APPLICATION NO.	FILING DATE	FIRST NAMED INVENTOR	ATTORNEY DOCKET NO.	CONFIRMATION NO.
09/786,507	05/01/2001	Arzhang Ardavan	117-342	8750
23117	7590 11/30/2004		EXAM	INER
	ANDERHYE, PC	SOUW, BERNARD E		
1100 N GLEBE ROAD 8TH FLOOR ARLINGTON, VA 22201-4714			ART UNIT	PAPER NUMBER
			2881

Application No.	Applicant(s)			
060	09/786,507	ARDAVAN ET AL.			
Office Action Summary	Examiner	Art Unit			
	Bernard E Souw	2881			
The MAILING DATE of this communication app Period for Reply	ears on the cover sheet with the c	orrespondence address			
A SHORTENED STATUTORY PERIOD FOR REPLY THE MAILING DATE OF THIS COMMUNICATION. - Extensions of time may be available under the provisions of 37 CFR 1.13 after SIX (6) MONTHS from the mailing date of this communication. - If the period for reply specified above is less than thirty (30) days, a reply - If NO period for reply is specified above, the maximum statutory period w - Failure to reply within the set or extended period for reply will, by statute, Any reply received by the Office later than three months after the mailing earned patent term adjustment. See 37 CFR 1.704(b).	36(a). In no event, however, may a reply be timed within the statutory minim

Fig. 1A

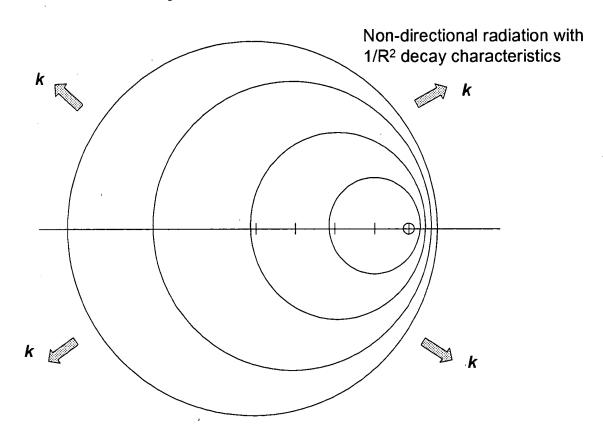
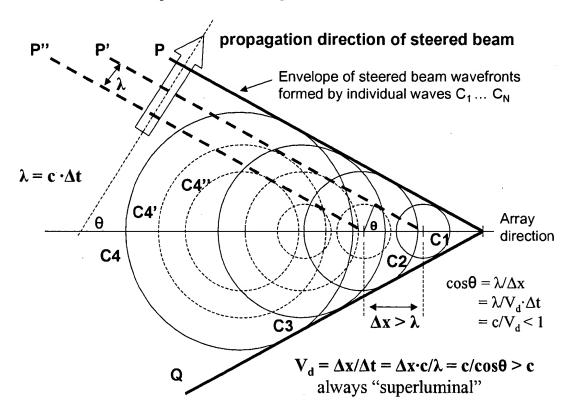
From the conventional beam steering theory (see Fig.1A) it is known that under imaginative "subluminal" conditions of $V_d < c$ the radiation is distributed over 4π steradians, i.e., spherical, whereas under imaginative "superluminal" condition of V_d the radiation is directional (beam steering mode). As discussed in sub-paragraph 43(j), the experimental results shown in Figs.11(a) to (d) does not show what is claimed by the invention. The "cusp" power is evidently (much) less than the "subluminal", i.e., spherical decay case. The apparent 1/R decay rate is thereby irrelevant, especially if the power is smaller than a $1/R^2$ decaying radiation. Such behavior is also inherent to

Fig. 2

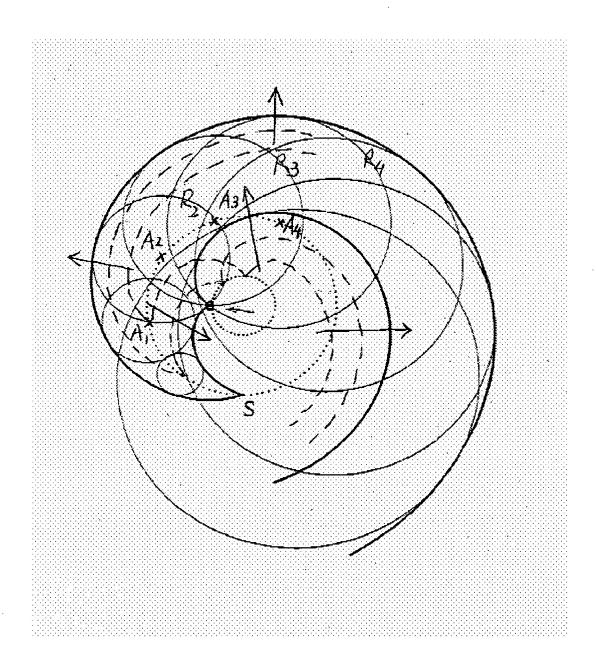
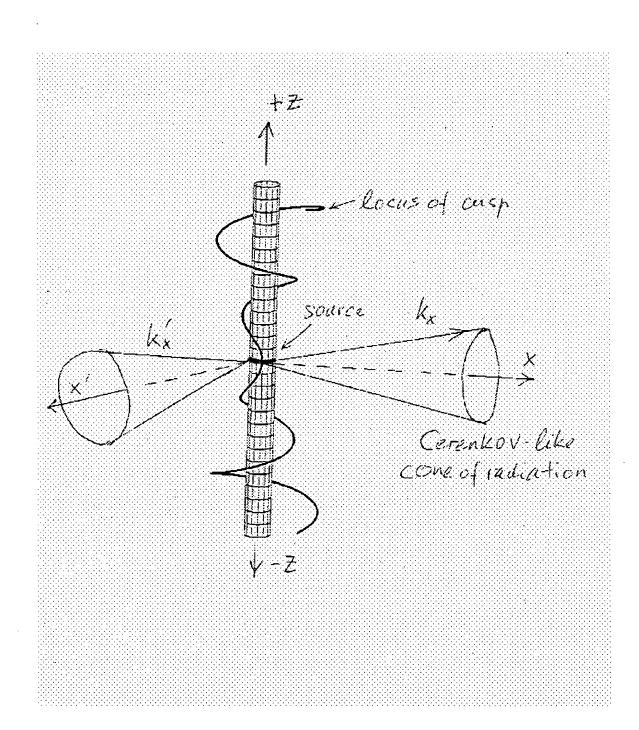
1B. Thus, a periodic sequence of curved envelopes in applicant's case (as represented by the dashed curves P', P" drawn by the examiner to Fig.1 of applicant's disclosure, reproduced in Fig.2 of this office action) is a topological equivalent of plane envelopes P', P", etc., forming a steered-beam plane wave in Fig.1B. This equivalency can be easily comprehended by those of even less than ordinary skill in the art, simply by topologically unfolding the winding cylindrical geometry shown in applicant's Fig.1 (reproduced in Fig.2 of this office action) and mapping it into the examiner's plain linear geometry of Fig.1B. In place of applicant's spirally winding envelopes $\Phi \pm$, we get a family of plane parallel envelopes.

Fig. 4

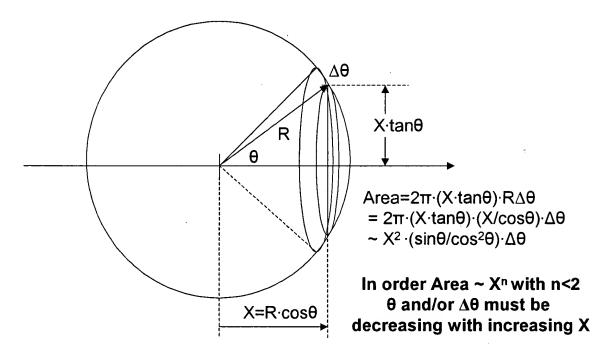
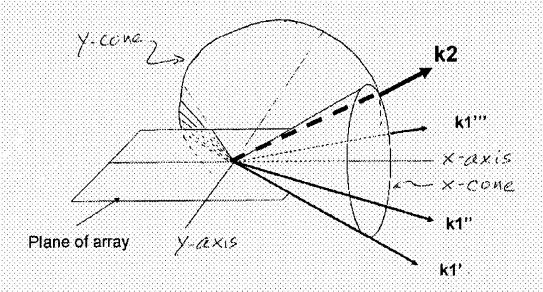
Effect of smearing out φ^ on spherical decay behavior

Fig. 5A

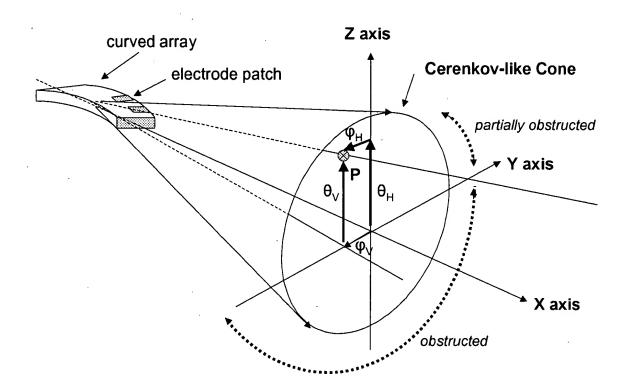
Compared to the conventional 2-dimensional array of Fig.5A, which emits a steered beam in a definite direction represented by the vector \mathbf{k} , the beam of applicant's linear array is distributed over the surface of a Cerenkov-like cone with apex angle θ determined by Eq.1c. The non-ideal geometry of applicant's array, mainly characterized by an unsymmetrical design in the X and Y direction, will only cause some minor modification to the cone apex angle θ and/or distortion of the cone surface distribution of the beamlets shown in Fig.5B. Specifically, because the bottom part of the array is fully obstructed by the electrode, the lower half of the cone is expected to be severely distorted and attenuated. Partially obstructed are also parts of the top.
